## CMB Meeting Minutes #182

SUBJECT: Configuration Management Board Meeting # 182 – Rev. No. 0

## CONTRACT CHANGE ORDER 082 – MOS 20” LOW PSI WATER PIPING RE-ROUTE

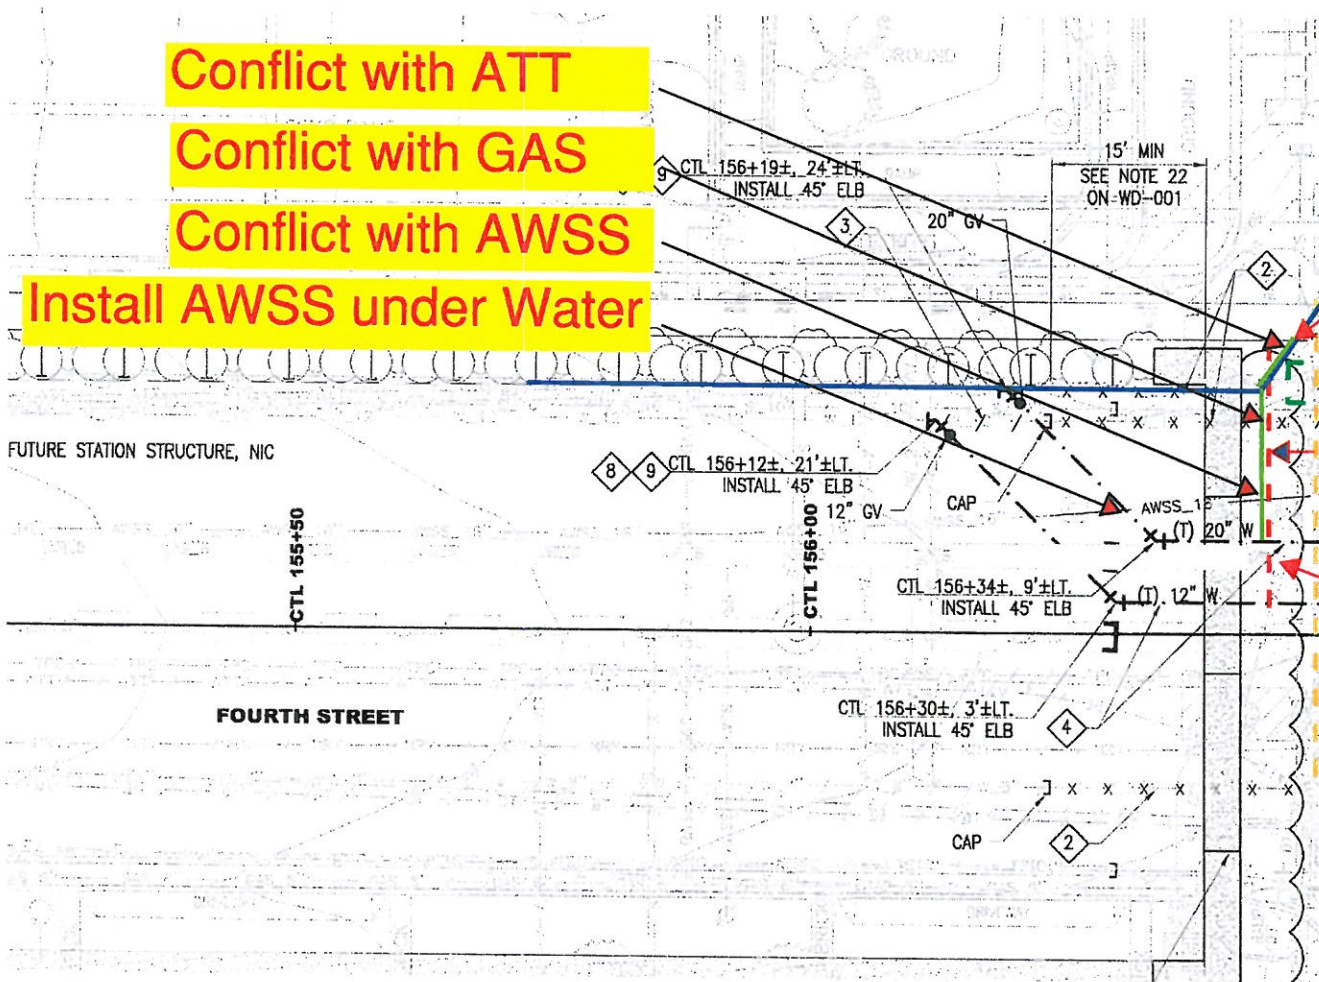
The Contractor submitted RFI No. 155 suggesting three (3) alternative alignments to reroute the waterline due to this conflict. The SFMTA allowed the Contractor to proceed with the installation alignment labeled 'option #1' in RFI No. 155. The modified alignment ran adjacent to an existing AT&T vault and required hand excavation of a hole underneath an existing gas main for the waterline to cross through. The revised alignment also reduced the overall length of waterline required to be installed by approximately 65 feet.

During installation of the waterline, per the revised alignment, the close proximity of existing utilities (see attached field sketch 1252-085) required that the Contractor utilize hand excavation methods and additional shoring. The Contractor's is claiming an additional two (2) days of work related to these additional excavation activities.

The Contractor claimed that the revised alignment required the use of a welded joint at the point of connection as opposed to the mechanical joint shown in the Contract drawings per the original alignment. The Contractor claimed the connection method lengthened the time required for SFWD's installation; therefore, additional SFWD support work was required to be performed by the Contractor. The Contractor's is claiming an additional three (3) days of work related to this additional SFWD support work.

The revised waterline alignment crossed an AWSS line at two (2) locations as opposed to the one (1) crossing shown in the original alignment. Additionally, the new alignment was in close proximity to a new AWSS trench excavated by the Contractor. As a result the Contractor was required to utilize hand excavation methods and additional shoring in order to protect the existing facilities. Additionally, the second crossing required the installation of an additional bell and stop collar. The Contractor's is claiming two (2) additional days of work related to these additional AWSS installation activities.

**Recommendation:** Accept partial justification of Merit for COR 082, for additional work required to reroute a 20" waterline, per the SFMTA's response to Request for Information (RFI) No. 155. Recommend compensating the Contractor for 3 additional days of work and the additional material cost for the additional AWSS fittings to complete the waterline at the new alignment. A credit is also due for 65 feet of 20" waterline not required to be installed per the original alignment required by Contract. There is no time extension requested or recommended for this work.
